**To:** Jim Lamphere  
**From:** Tony Santilli  
**cc:** Sherri Desjardins  
**Date:** 07/27/2020  
**Re:** 15 Frontier Rd solar project

To: Jim Lamphere, Hopkinton Town Planner
From: Ralph A. Palumbo, President of Revity Energy, LLC
Date: July 27, 2020
Re: Frontier Road – Proposed Conditions

**11.309 MW DC and 9.250 MW AC Solar Farm**

Sheet No.	Description
1	Overall Site Layout Plan
2	Site Plan
3	Site Plan
4	Site Plan
5	Site Plan
6	Site Plan
7	Site Plan
8	Site Plan
9	Site Plan
10	Site Plan
11	Site Plan
12	Site Plan

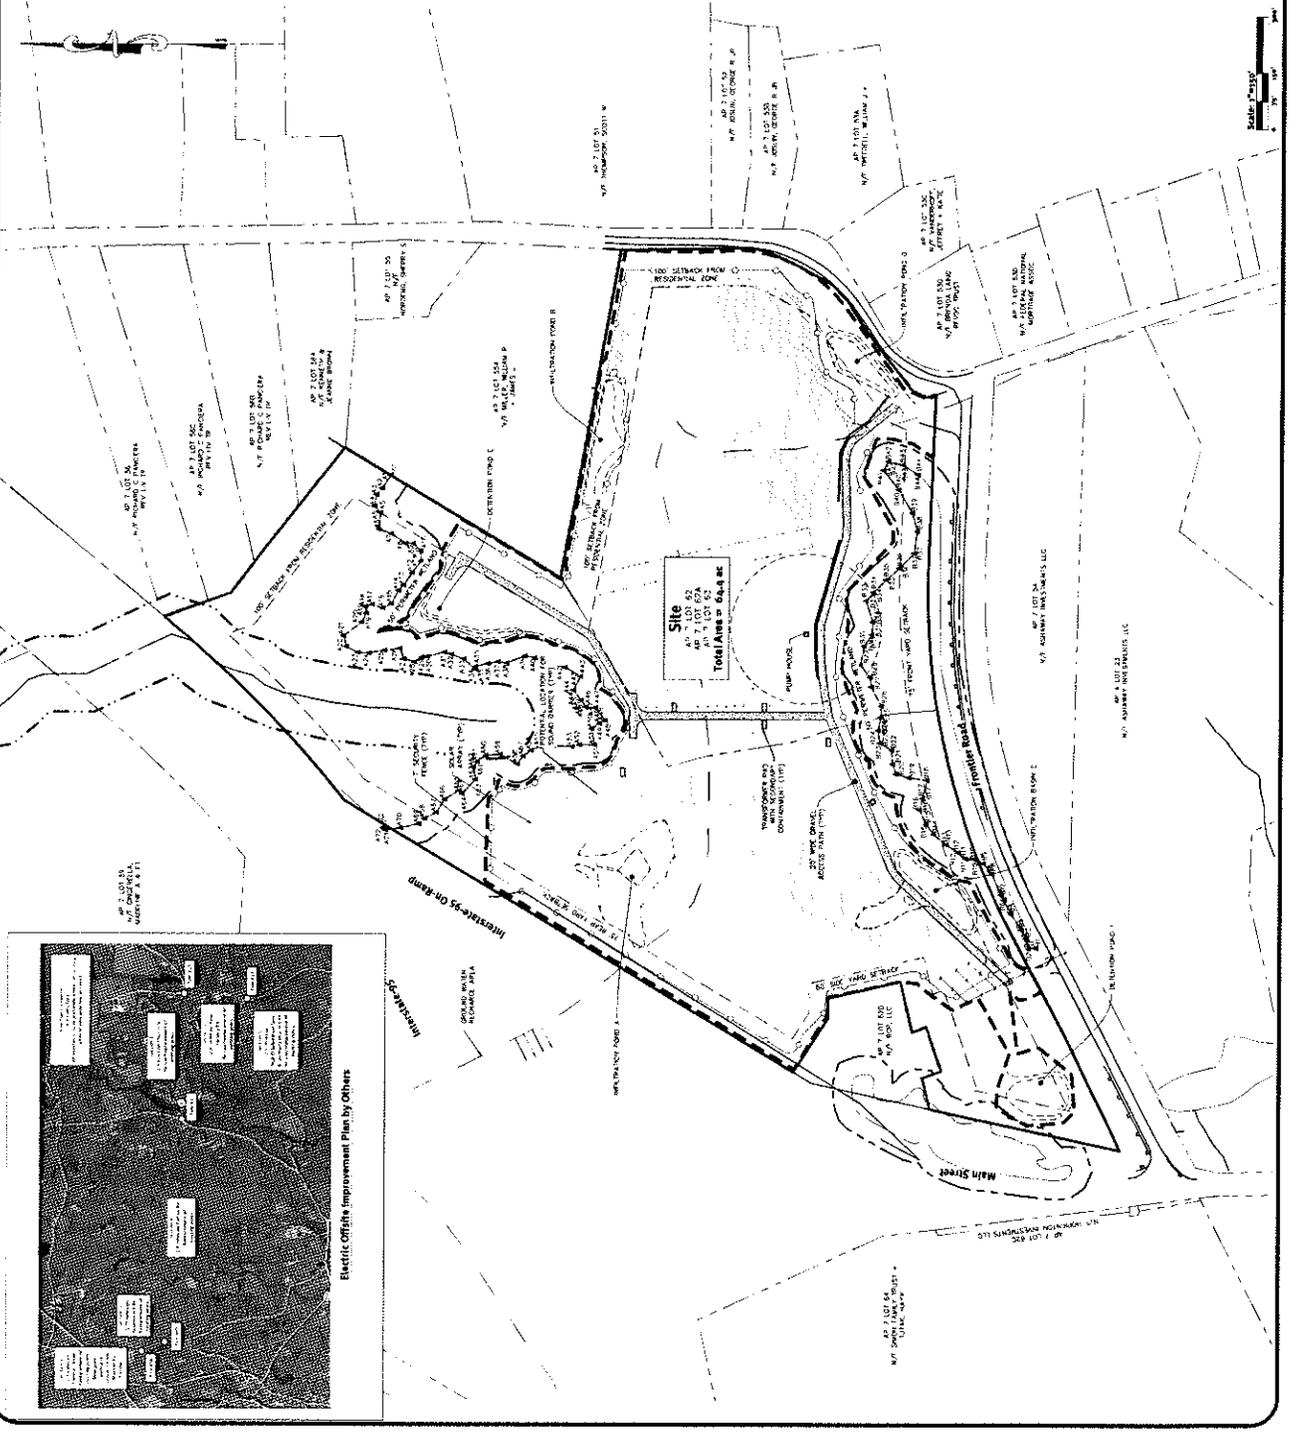
1. The rear property line is the most distant point from the front as described in the zoning ordinance definitions. This particular parcel indicates the rear line as triangular in shape, which according to our regs, would suggest an assumed line at least 10 feet in length parallel to and at a maximum distance from the front property line.

2. All other property lines on this irregularly shaped parcel are considered side property lines.
3. This office does not consider the westerly maintenance road indicated on the proposal as an access road. Therefore, it should be removed from the plan and maintained as indicated as turf.

4. The footnote (2) indicated in section 6 of the zoning ordinance, Dimensional Regulations, seems clear that all setback areas abutting residential boundary shall be maintained in a vegetative state.  
However, the PSES ordinance itself, specifically states in Section C (1), paragraph 2, "Clearing of any existing vegetation within the front, rear and side setbacks areas is prohibited, unless explicitly approved by the planning board."

5. Drainage and detention ponds, swales, etc., may be constructed outside the setbacks as proposed. The drainage apparatus is allowed outside setback areas to ensure proper function as determined by professional engineers.
